# SERVICE INSTRUCTION

Service Instruction No. 1506A  
(Supersedes Service Instruction No. 1506)  
Engineering Aspects are  
FAA Approved

**SUBJECT:** Replacement of Impulse Coupling Magnets on Four-Cylinder Engines

**Figure 1**  
**Conversion of Impulse Coupling Magneto Configurations to Shower of Sparks Type Magneto Configuration (View from Rear of Engine)**

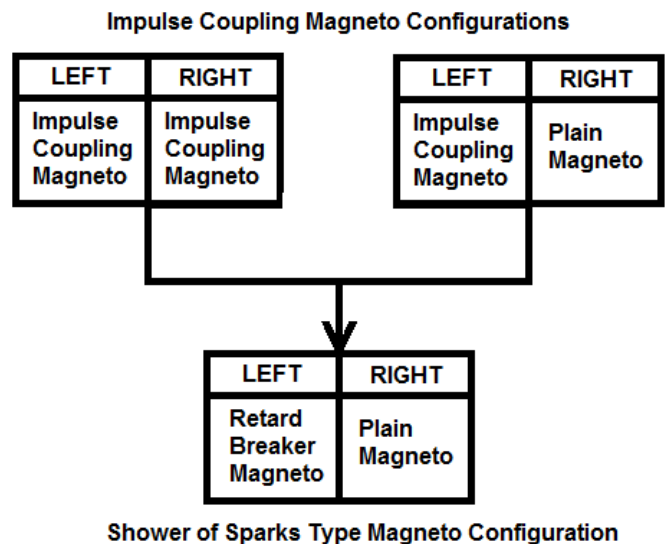
This Service Instruction contains instructions to replace impulse coupling magnets on affected four-cylinder Lycoming engine models with a left retard breaker magneto, a right plain magneto, and an ignition vibrator. This replacement changes the configuration from an impulse coupling to a shower of sparks type configuration (Figure 1).

**Figure 2**  
**Impulse Coupling Magneto and Plain Magneto**  
**- Example Impulse Coupling Magneto Configuration**

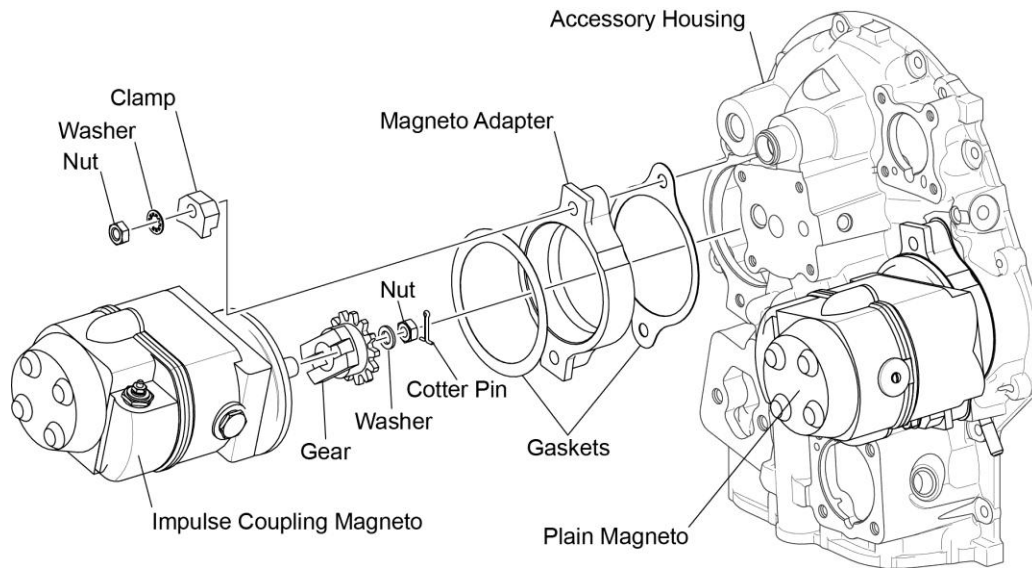
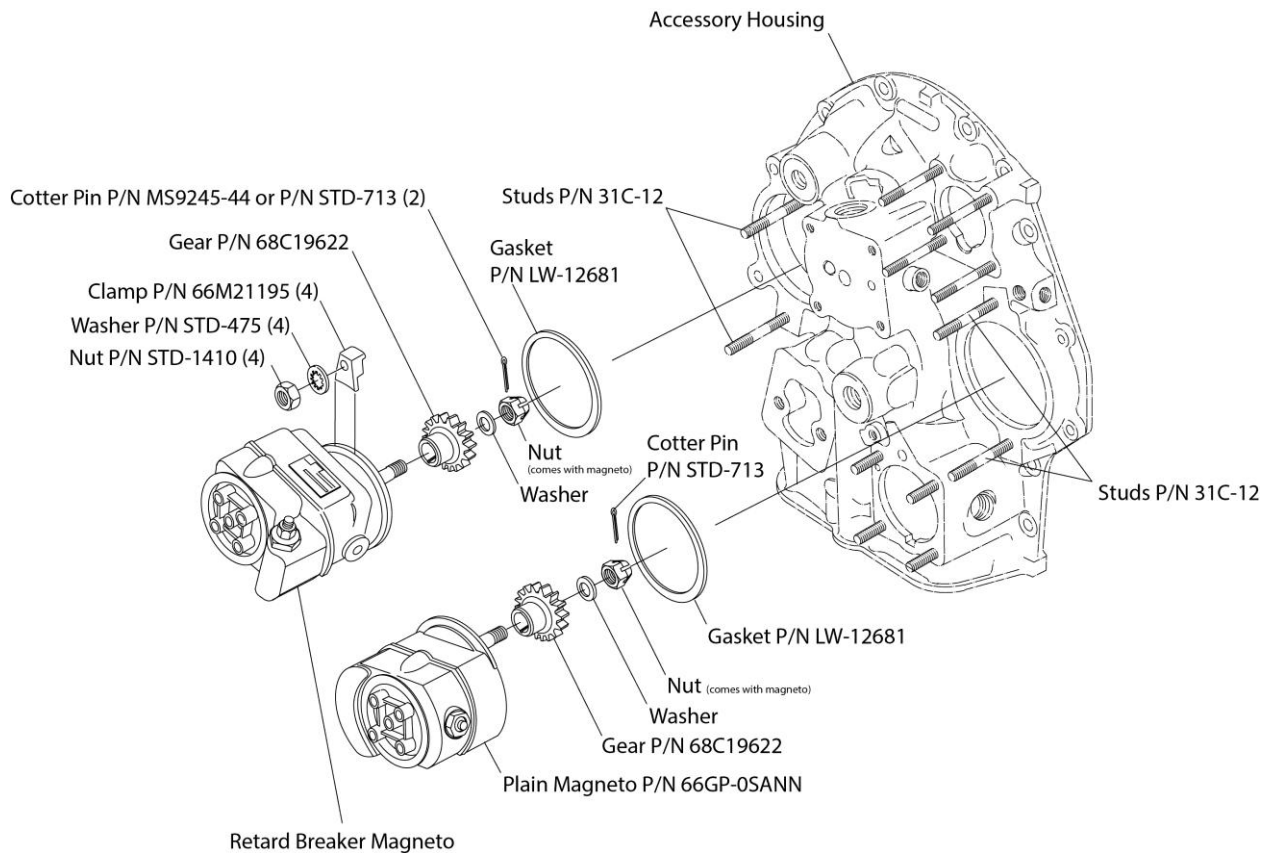
1. Remove and discard the impulse coupling magneto, two nuts, two washers, two clamps, gear, cotter pin, magneto adapter, and two gaskets from the two studs on the accessory housing (Figure 2).

2. Remove and discard the two studs from the left side of the accessory housing (Figure 2) and install two new studs P/N 31C-12 (Figure 3) to the specified driven height of 0.94 to 0.98 in. (24 to 25 mm). If a minimum drive torque of 25 in.-lb. (2.8 Nm) cannot be reached, install the next larger size oversize studs.

1. Remove and discard the impulse coupling magneto, two nuts, two washers, two clamps, gear, cotter pin, magneto adapter, and two gaskets from the studs on the accessory housing (shown on the left side only in Figure 2 example).

2. Remove and discard the two studs from the right side of the accessory housing (shown on left side in Figure 2) and install two new studs P/N 31C-12 (Figure 3) to the specified driven height of 0.94 to 0.98 in. (24 to 25 mm). If a minimum drive torque of 25 in.-lb. (2.8 Nm) cannot be reached, install the next larger size oversize studs.

3. Select the correct replacement retard breaker magneto based on ignition timing (Figure 3).
4. Install a new retard breaker magneto, two new nuts, two new washers, two new clamps, a new gear, new cotter pin, and new magneto gasket (refer to Table 1) on the new studs on the left side of the accessory housing (Figure 3).

3. Install a new plain magneto, two new nuts, two new washers, two new clamps, a new gear, new cotter pin, and new magneto gasket (refer to Table 2) on the two new studs on the right side of the accessory housing (Figure 3).
